# Regency Garments Ltd (Unit 1)

Plot # 60-62, Sector # 1, CEPZ, Chittagong, Bangladesh  
(22.291652N 91.773435E)

21 April 2015

# Observations

## Architectural drawing showing proposed new canteen and ancillary accommodation

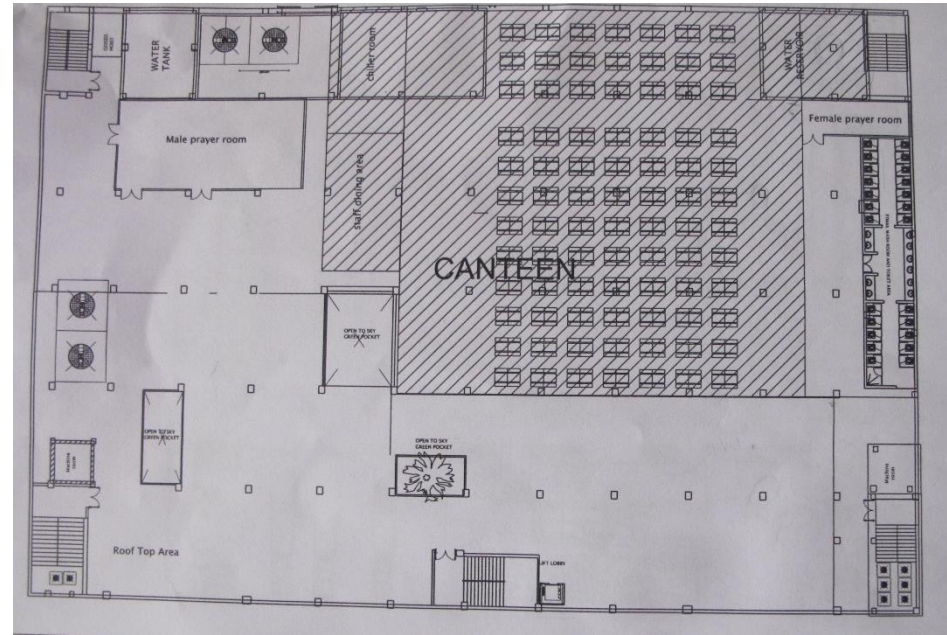
Proposed additional Canteen and ancillary accommodation shown on architectural layout but no account taken for this on structural drawings  
Proposed construction is RC stub columns, steel columns and lightweight steel roof.  
Brickwork infill around perimeter of canteen and other accommodation (all brickwork observed on site is solid 250mm thk walls). Toilets shown with undetermined floor build-up

Item No.	Observation	Recommended Action Plan	Recommended Timeline
1	Undocumented proposed Canteen and ancillary accommodation on Roof Undocumented proposed Canteen and ancillary accommodation on Roof	Building engineer to review proposed additional structures and loading and assess capacity of the existing structure to support the loads.	6-months
2	Undocumented proposed Canteen and ancillary accommodation on Roof Undocumented proposed Canteen and ancillary accommodation on Roof	Document the additional structures fully including calculations and updated as-built drawings	6-months
3	Inaccuracies in 'as-built' structural drawings	Building engineer to collect information and produce accurate and complete as-built documentation at soonest opportunity.	6-months
4	Undocumented Mezzanine floor structures between Ground and 1st Floors	Structural engineer to assess the existing steel and composite structure and confirm its capacity to support the applied loading, particularly the foundation support structure.	6-months

As-built Structural Drawing showing measured dimensions

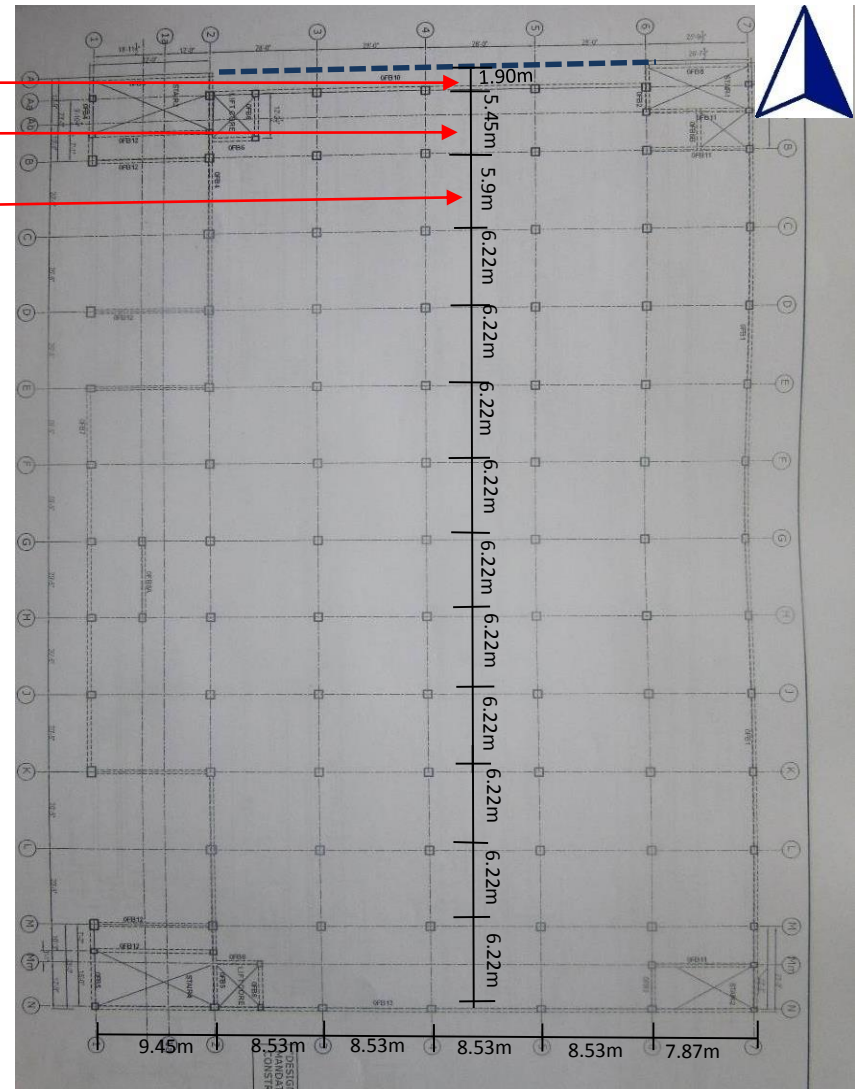
Cantilever not shown  
on Structural drawings

Dimensions of these  
two bays incorrect on  
structural drawings

As-built structural drawings do not show 1.9m cantilever on N side of the building, and two end bay dimensions are incorrect

# Undocumented Mezzanine floor structures at Ground floor level

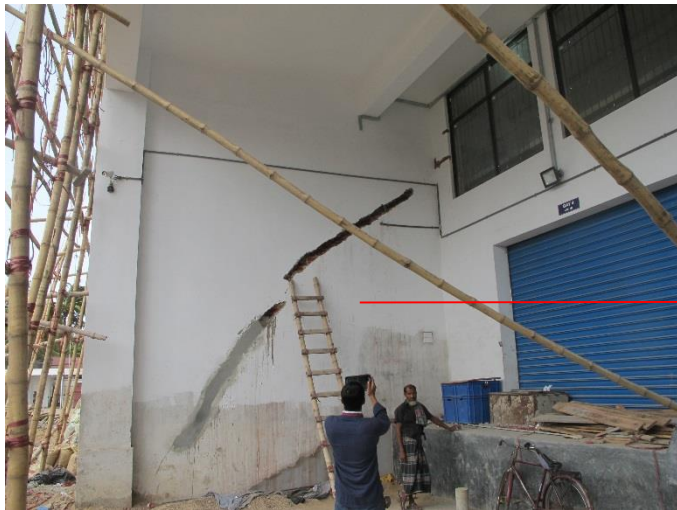
**ITEM 3** – Undocumented Mezzanine floor structures

5	Undocumented Mezzanine floor structures between Ground and 1st Floors	Document the additional structures fully including calculations and updated as-built drawings .	6-months
6	Cracking of brickwork panel adjacent to loading bay	Repair cracks in brickwork panel and monitor for further cracking.	6-months
7	Cracking of brickwork panel adjacent to loading bay	Structural engineer to review if further cracking occurs	6-months

# Cracking of brickwork panel adjacent to loading bay

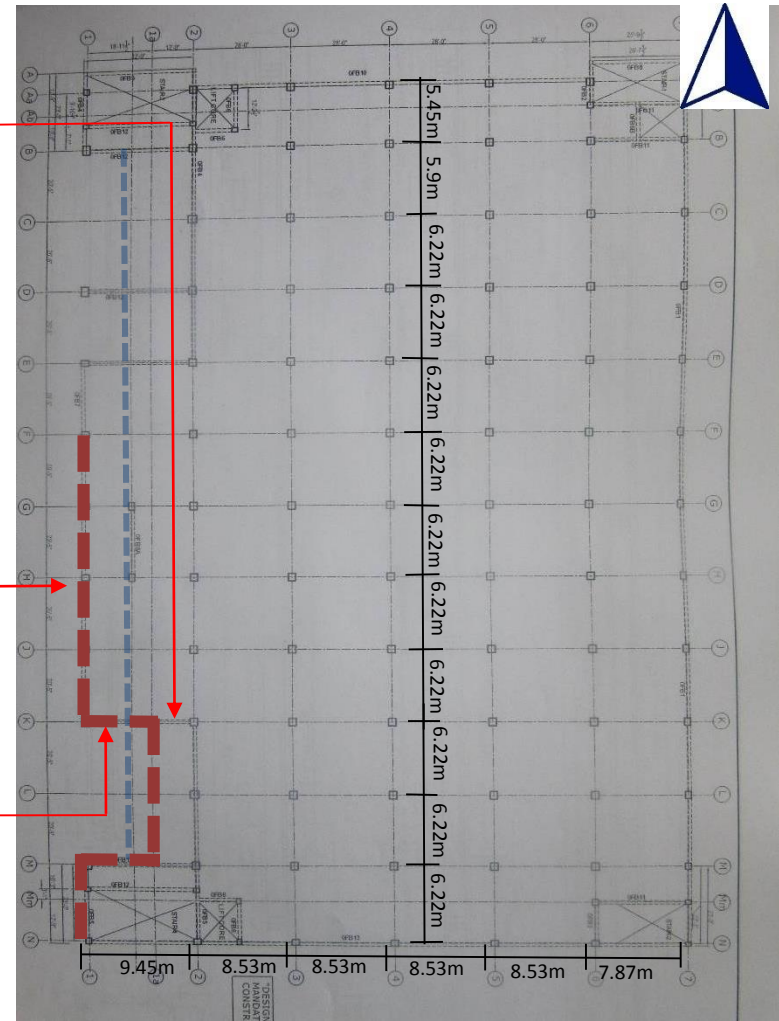
Hairline crack in beam

Large crack in brick wall panel

Diagonal crack in brick wall panel, suggest some subsidence in area of loading bay

Area adjacent to loading bay where cracking occurred
